# Rockwell service bulletin

Service Bulletin No. SB-AG-6  
6 June 1975

## REPLACEMENT OF ENGINE OIL COOLER VALVE

MODELS AFFECTED: MODEL S-2R, SERIAL NO'S 5000R THRU 5026R.

Figure 1.

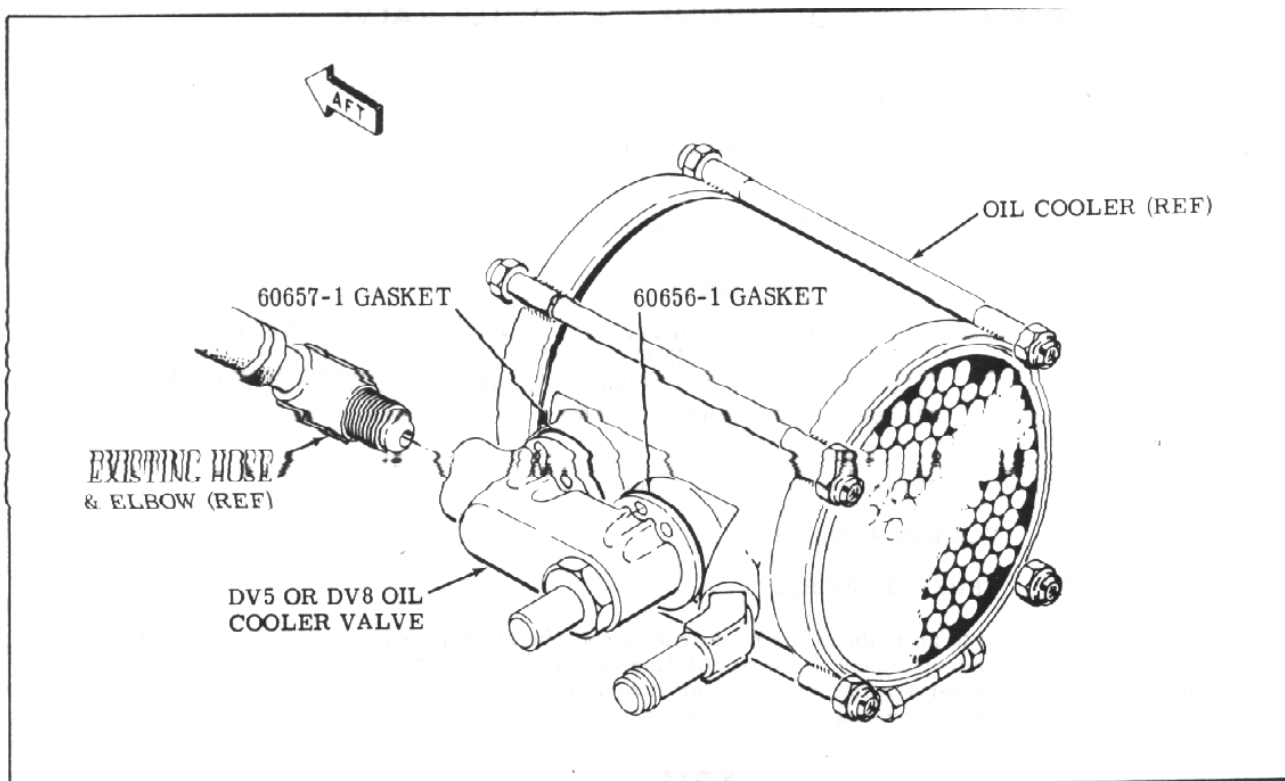
REASON FOR PUBLICATION: TO ASSURE THAT CORRECT VALVE IS INSTALLED ON ENGINE OIL COOLER.

3. Remove nuts and rod attaching engine oil cooler to airplane and remove oil cooler.
4. Remove existing elbow from oil cooler valve.
5. Remove and discard existing valve, thermostat and valve gaskets from engine oil cooler (see Figure 1.).
6. Install DV5 or DV8 oil cooler valve, 60656-1 gasket and 60657-1 gasket on oil cooler using existing hardware and safety wire attaching screws with 0.032-inch diameter stainless steel safety wire (see Figure 1.).

Order DV5 valve for aircraft equipped with oil cooler Part No. U-6010 with a D5 valve and order DV8 valve for aircraft equipped with oil cooler Part No. U-6010 with a D8 valve.

QTY	PART NO.	DESCRIPTION
1 ea.	DV5 (with U-3235-5 thermostat)	Oil Cooler Valve
	or	
1 ea.	DV8 (with U3236-3 thermostat)	Oil Cooler Valve
